ADDENDUM NO. 2

This addendum includes Item Number 2-1 thru 2-28. This addendum item shall be fully incorporated into the Bidding/Contract Documents and have the same force and effect as though originally included.

**Life Science Collaboration
 UNL Food Science and
 Technology**

1910 N Antelope Valley
 Parkway
 Lincoln, Nebraska
 TCEP No.: 716-006-13

BELOW FLOOR PLUMBING PLAN - AREA B3
SCALE: 1/4" = 1'-0"

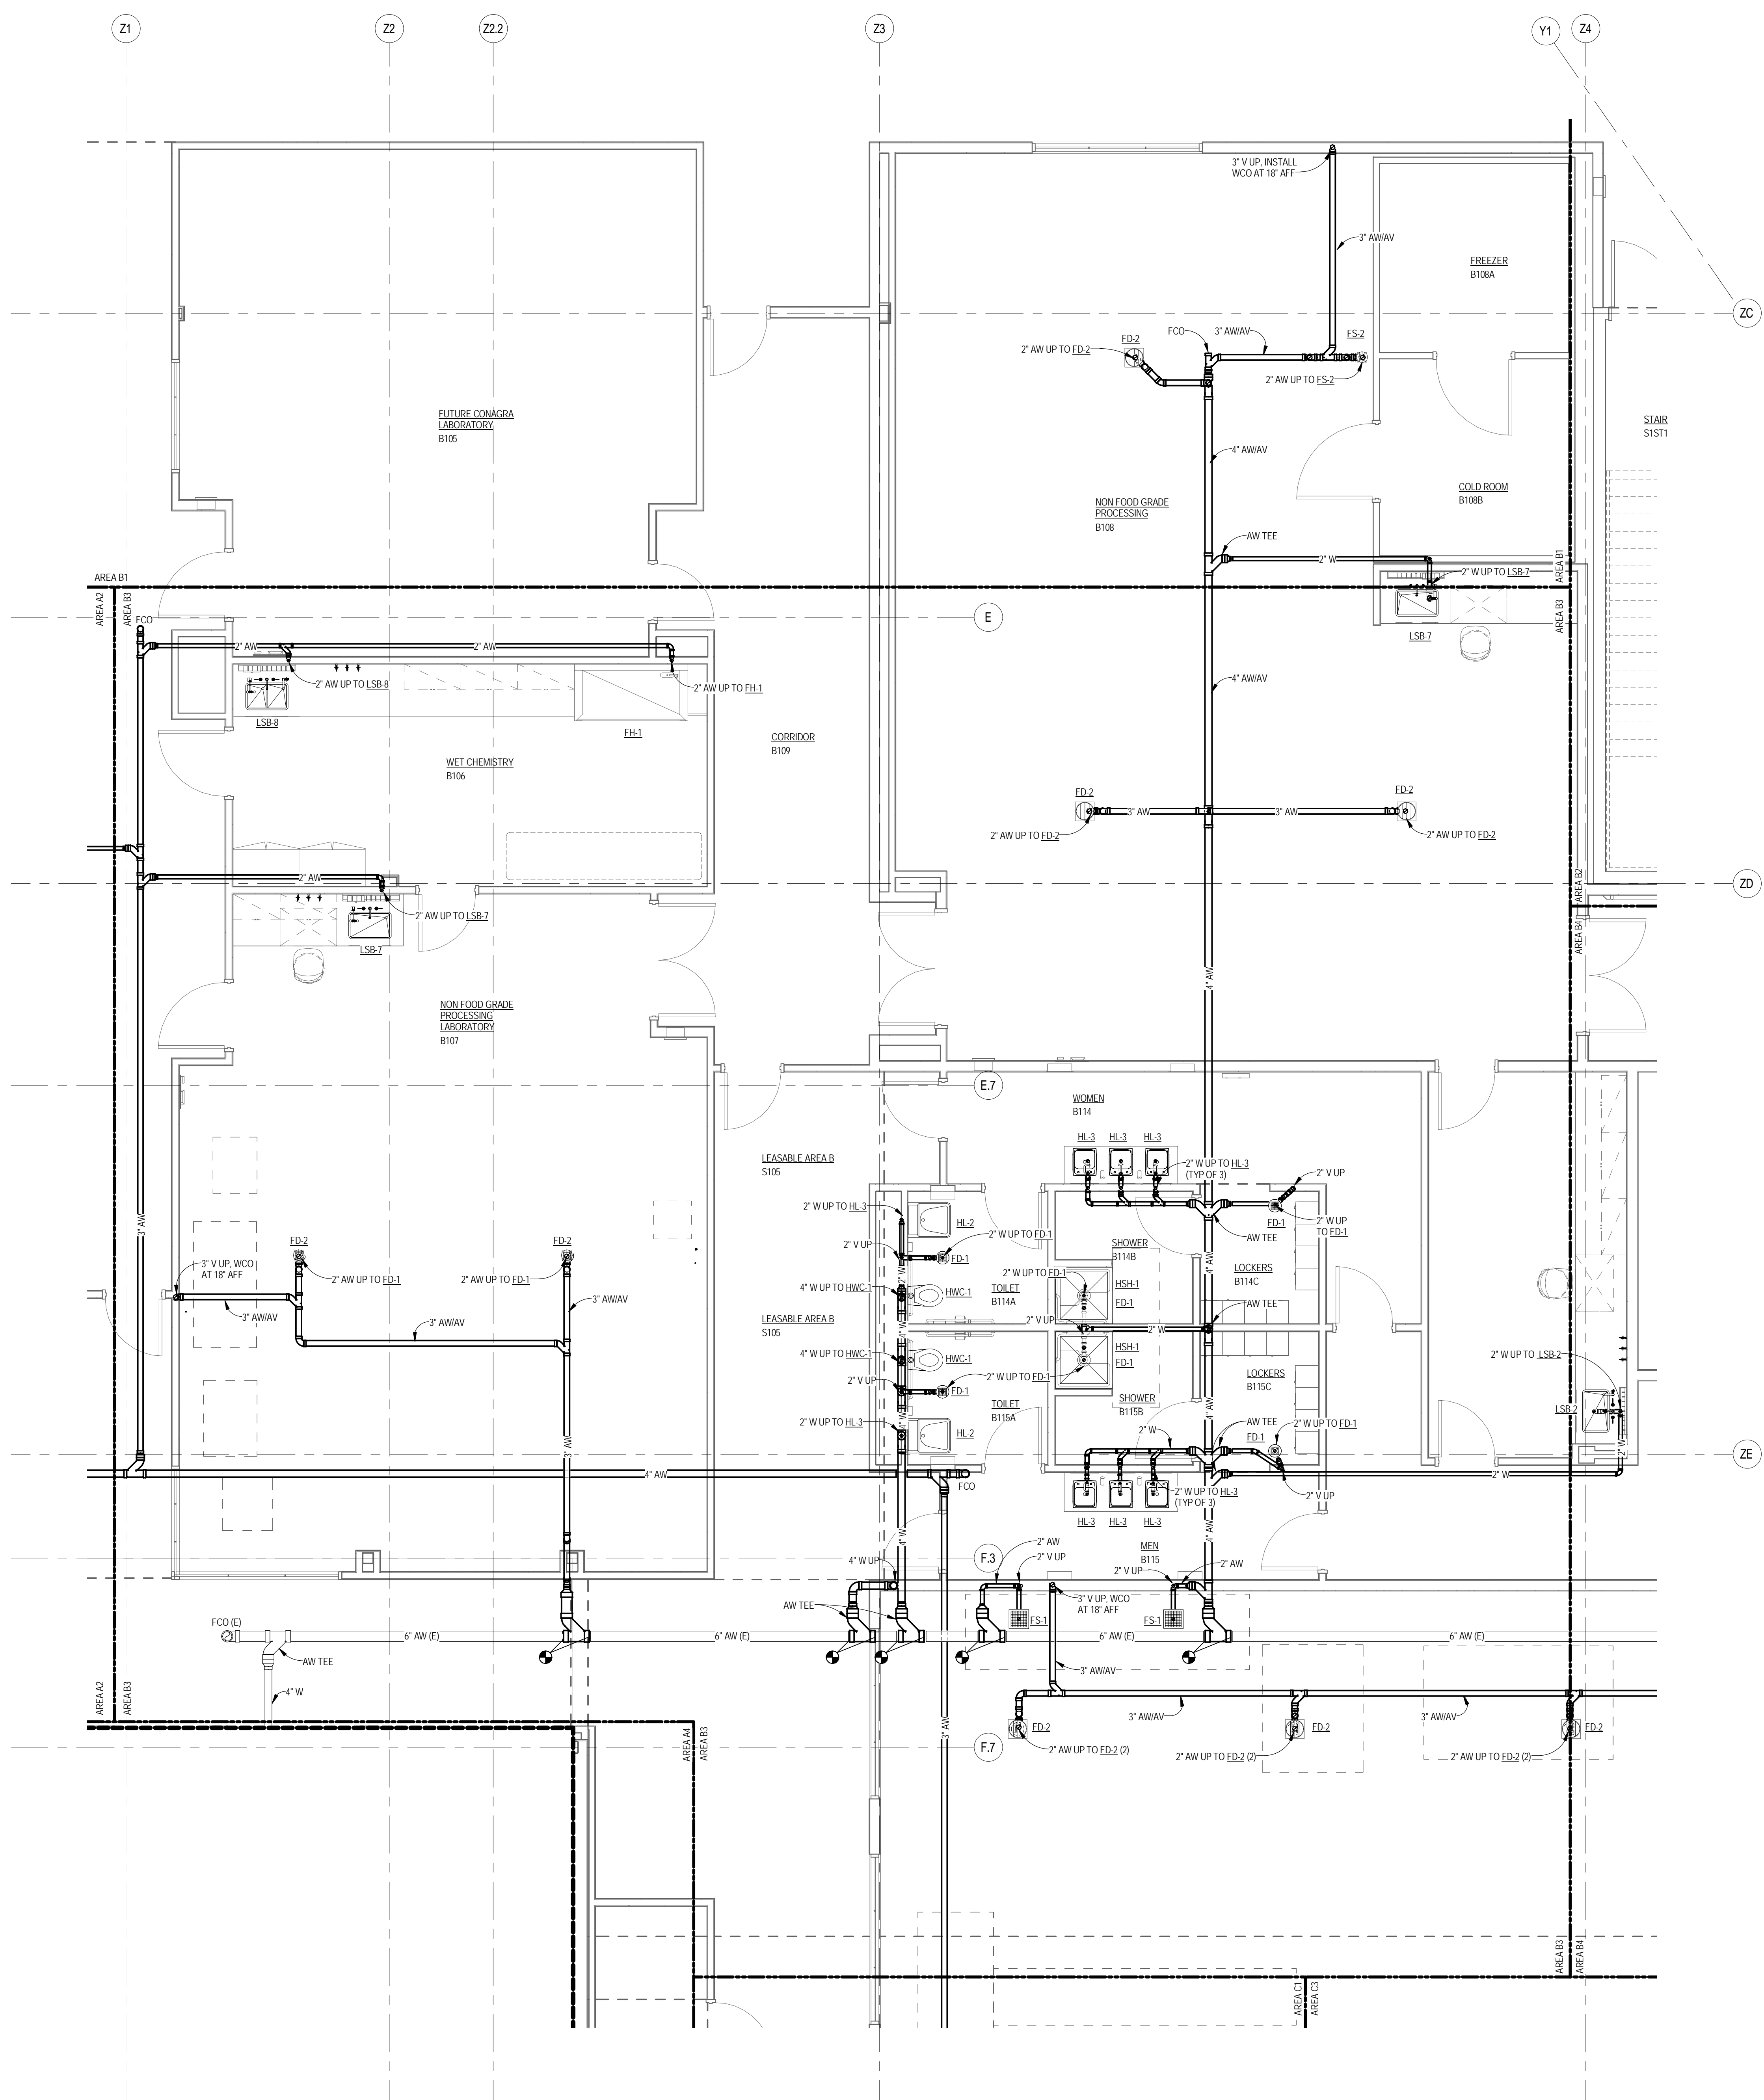
Item 2-21: P1.05 - P1.08 – Below Floor Plumbing Plans

Refer to revised below floor plumbing plans. All floor drains, floor sinks, and other sinks in the plant spaces (rooms B107, B108, C101, C102, C104, and C105) shall be served with polypropylene (PP) waste piping. It is denoted as AW on plan. Piping below grade may be non-fire-rated pipe, but must transition to fire-rated at the floor.

For venting of these fixtures, cast iron may be provided above the rim level of the fixture, and is denoted as normal "vent" on plan. For combination waste/vent lines, cast iron may be run in the wall for the venting, above the floor level.
